Public Comment No. 22-NFPA 14-2014 [New Section after 1.4]

Public Comment No. 4-NFPA 14-2014 [Section No. 4.1.4]

FIGURE A.7.3.2.2.1 Horizontal Exits

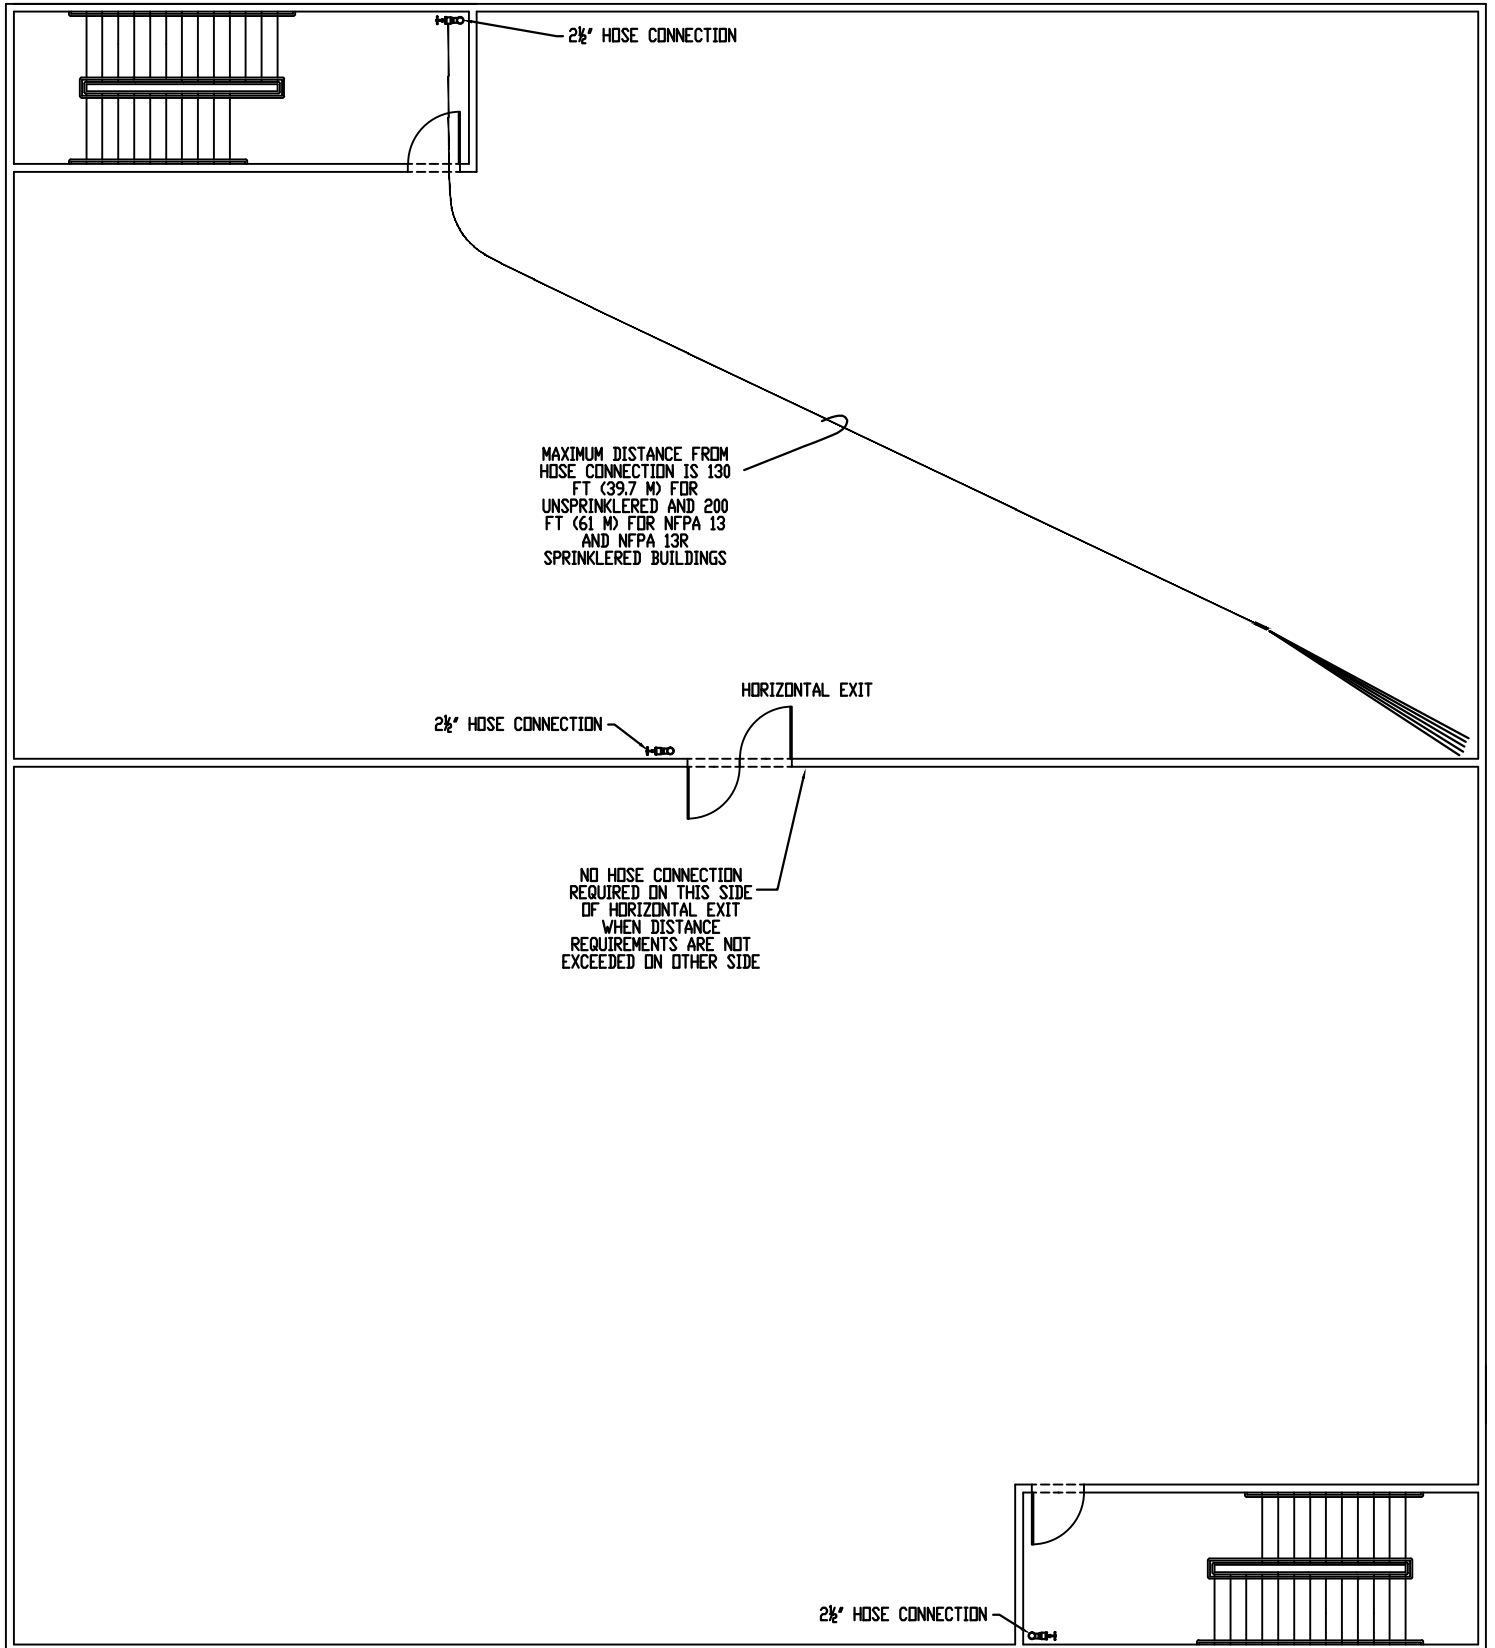
Hose connections on one side of a horizontal exit shall not be required where another outlet on that side of the horizontal exit can reach the portions of the building on the other side of the horizontal exit within the distances required by [7.3.2.2.1.1](#) or [7.3.2.2.1.2](#) that would have been protected by the outlet that was omitted.

The attached language is proposed to correlate NFPA 14 with the IBC. As currently written, NFPA 14 is opposite of the building code. A revised annex diagram is part of this change as well.

Where all floor areas are reachable from an exit stairway hose connection on the same side of a horizontal exit within the distances required by [7.3.2.2.1.1](#) or [7.3.2.2.1.2](#) as applicable, the hose connection on the other side of the horizontal exit shall be permitted to be omitted.

Figure A.11.5.2(a)

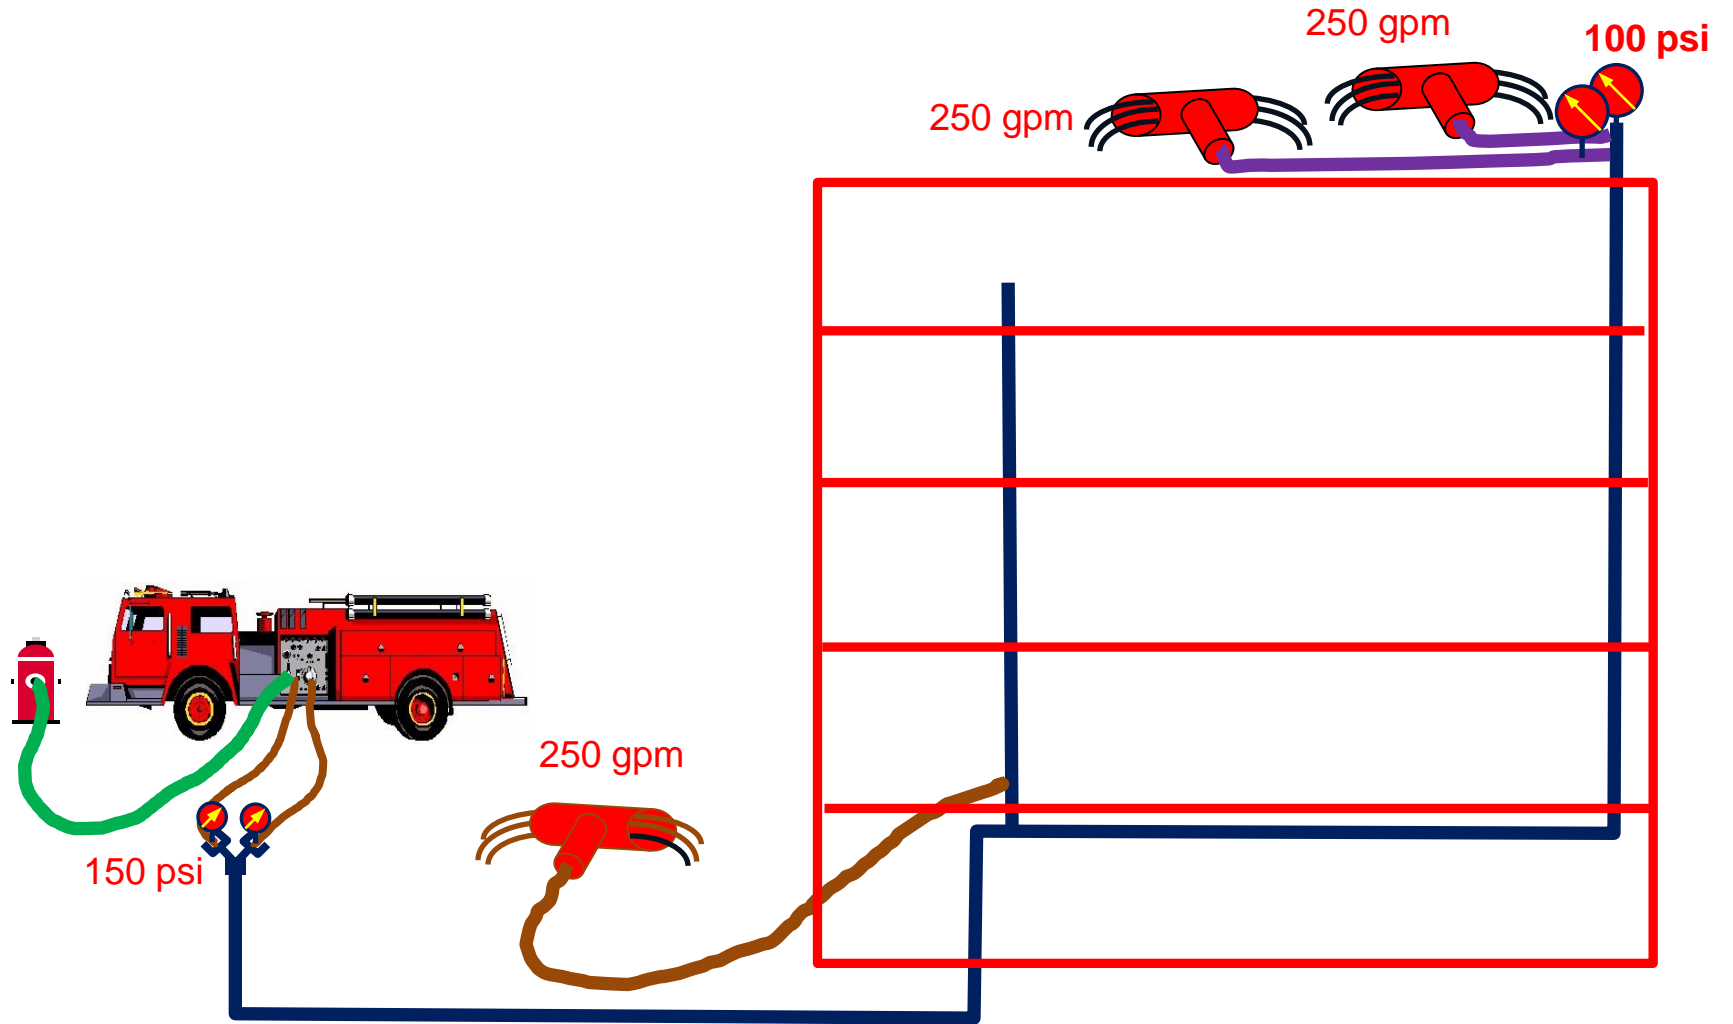
It is not always necessary to use a pump to test a standpipe system. The proposed Annex material shows 3 test methods, the last of which does not use a pump. Consider where one provides 750 gpm at 75 psi at the FDC inlet resulting in 25 psi available at the hydraulically most remote standpipe outlet. If the standpipe required 100 psi at the hose valve, then adding 75 psi to both the FDC inlet pressure (75 psi) and the remote hose valve pressure (25 psi) means that if the FDC were supplied at 150 psi (75 psi + 75 psi), then 100 psi (25 psi + 75 psi) would be available at the hose valve outlet.

A.11.5.2. It is not always necessary to use a pump to test a standpipe system. See Figure A.11.5.2(a), Figure A.11.5.2(b), and Figure A.11.5.2(c) for examples of possible test methods. When using the method shown in Figure A.11.5.2(c) it is necessary to flow the system demand while observing the pressures at the FDC inlet and the hydraulically remote standpipe hose valve. While the standpipe test may indicate that a greater pressure is required at the FDC inlet than what was indicated in the hydraulic calculations, this is not necessarily a cause for failing the test. This greater pressure, if acceptable to the AHJ based on the ability of the fire apparatus to provide the additional pressure, needs to be incorporated into the standpipe sign required at the FDC by Section 6.4.5.2.2.

Figure A.11.5.2(c)

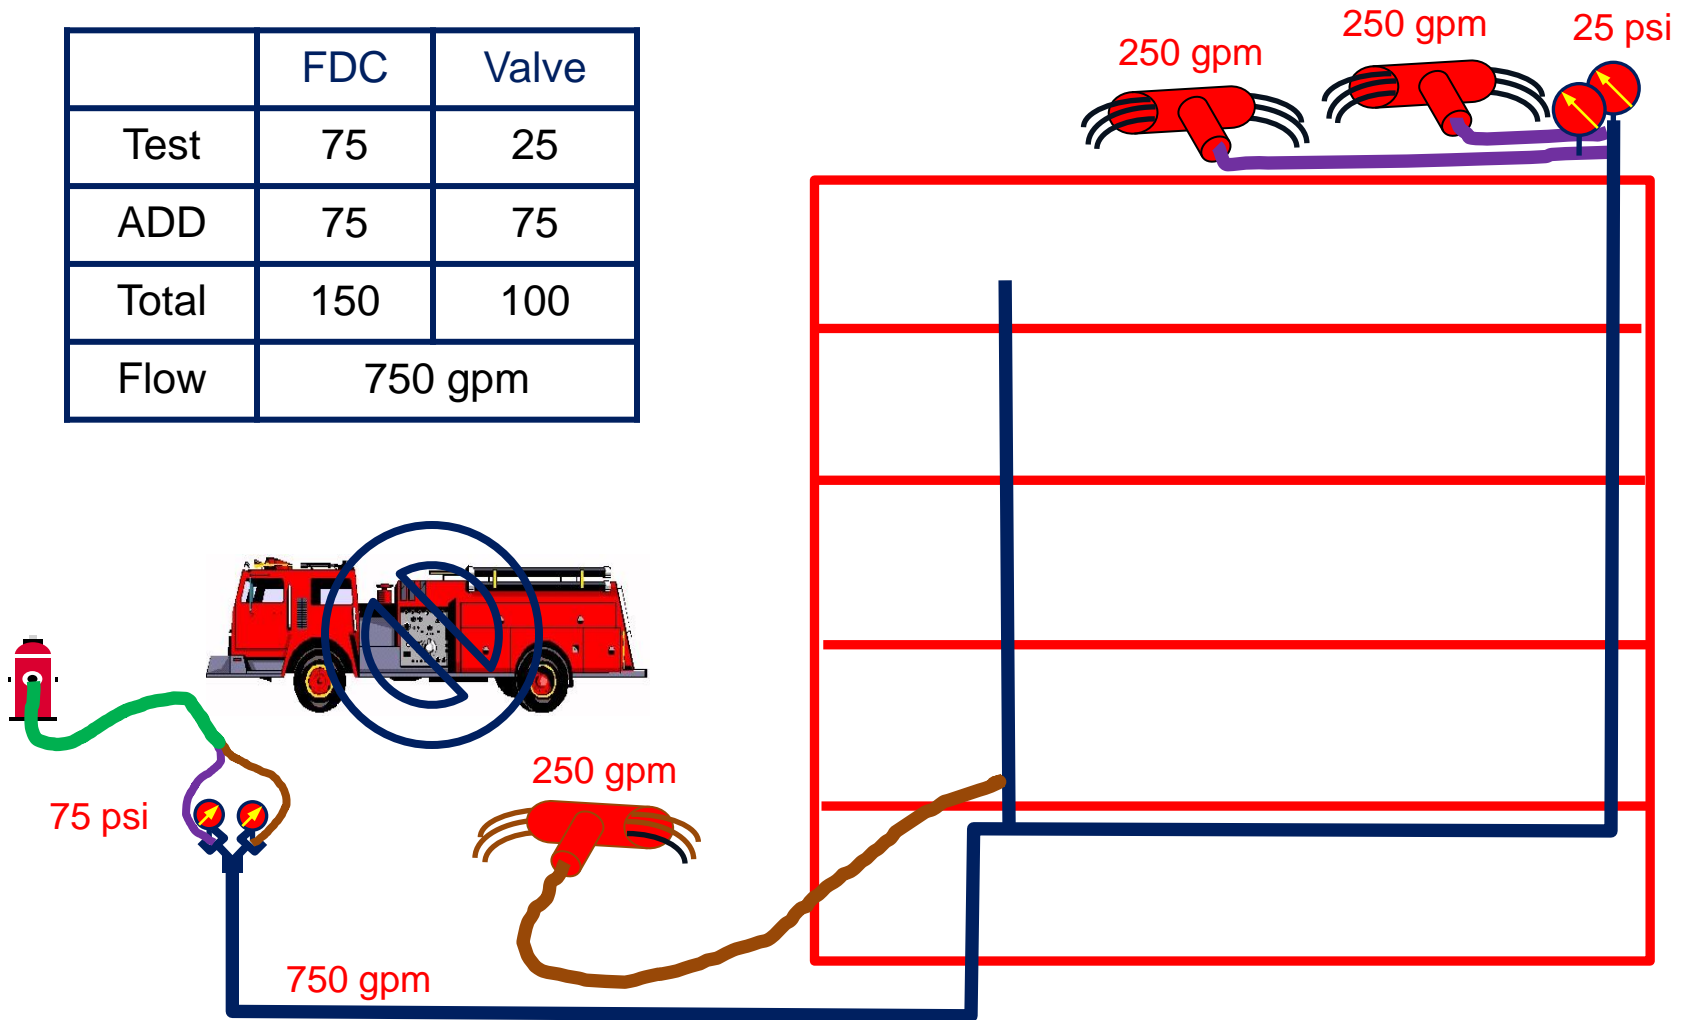
FDC	Valve
Test	75	25
ADD	75	75
Total	150	100
Flow	750 gpm

FIGURE A.7.3.2.5 Single Hose Valve in Open Stairs/Corridors/Breezeways

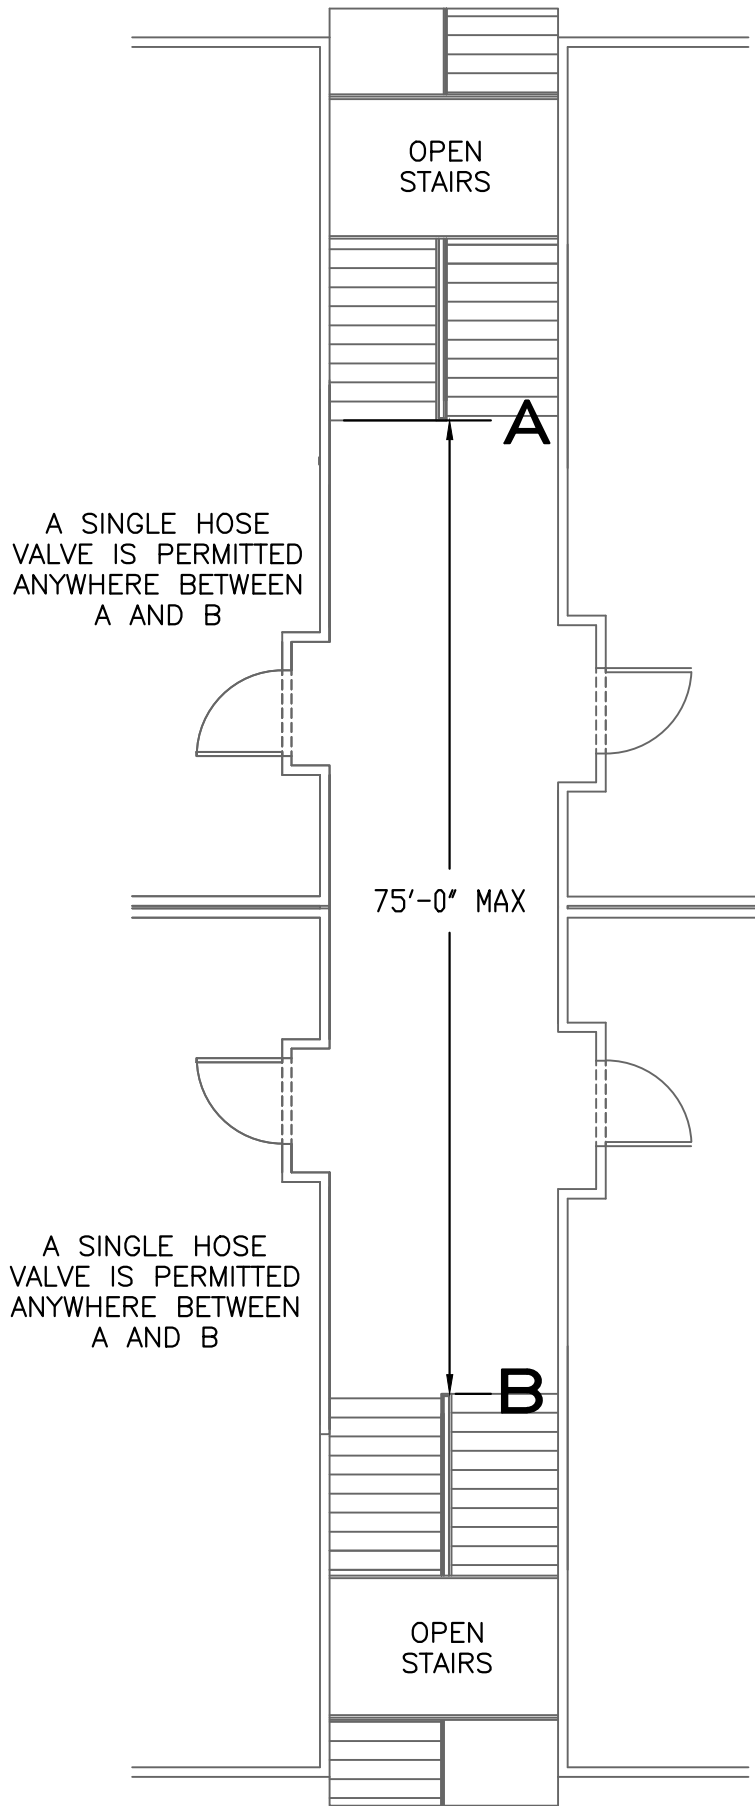
This section and figure is being submitted on behalf of the Horizontal Exit task group. The task group was assigned the task to create an annex figure for section A.7.3.2.5.

A.7.3.2.5 The standard in section 7.3.2.1 requires that a standpipe be provided in each required exit stairwell. One arrangement that may be found in certain residential buildings is to have (2) remotely located exit stairs providing the occupants two distinct means of egress. This section allows a single hose connection to be located anywhere between the exit stairs provided the exit stairs are open and are located within 75 ft (23 m) of each other. (See figure A.7.3.2.5).
